## DEVELOPMENT APPLICATION ASSESSMENT REPORT

<b>Application Number:</b>	DA2021/1229
----------------------------	-------------

<b>Responsible Officer:</b>	Catriona Shirley
<b>Land to be developed (Address):</b>	Lot 1 DP 900658, 7 Pavilion Street QUEENSCLIFF NSW 2096
<b>Proposed Development:</b>	Alterations and additions to a dwelling house
<b>Zoning:</b>	Warringah LEP2011 - Land zoned R2 Low Density Residential
<b>Development Permissible:</b>	Yes
<b>Existing Use Rights:</b>	No
<b>Consent Authority:</b>	Northern Beaches Council
<b>Land and Environment Court Action:</b>	No
<b>Owner:</b>	James David O'Leary Megan Oi Qwan Chan O'Leary
<b>Applicant:</b>	James David O'Leary

***Photo 5: Water views impacted directly to the north from the lounge window.***

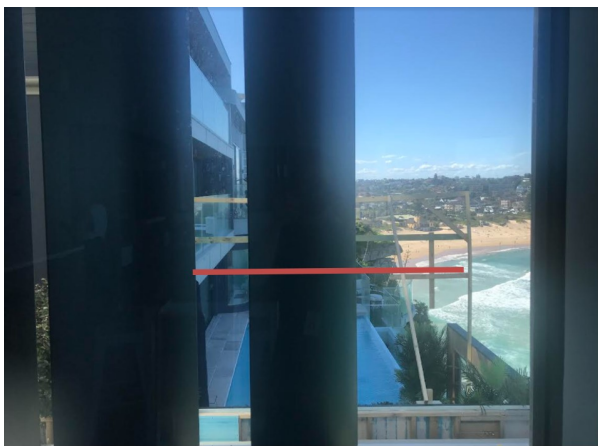
The proposal will partly encroach into the north-eastern side view corridor and impact the area of water views and a small amount of beach sand views available from the bedroom, kitchen/lounge room windows. All significant Freshwater Beach and headland views will be retained.

In this regard, the view loss is considered to be "minor", based on the side boundary view lines to be impacted and the retention of all significant areas, such as Freshwater Beach and Headland.
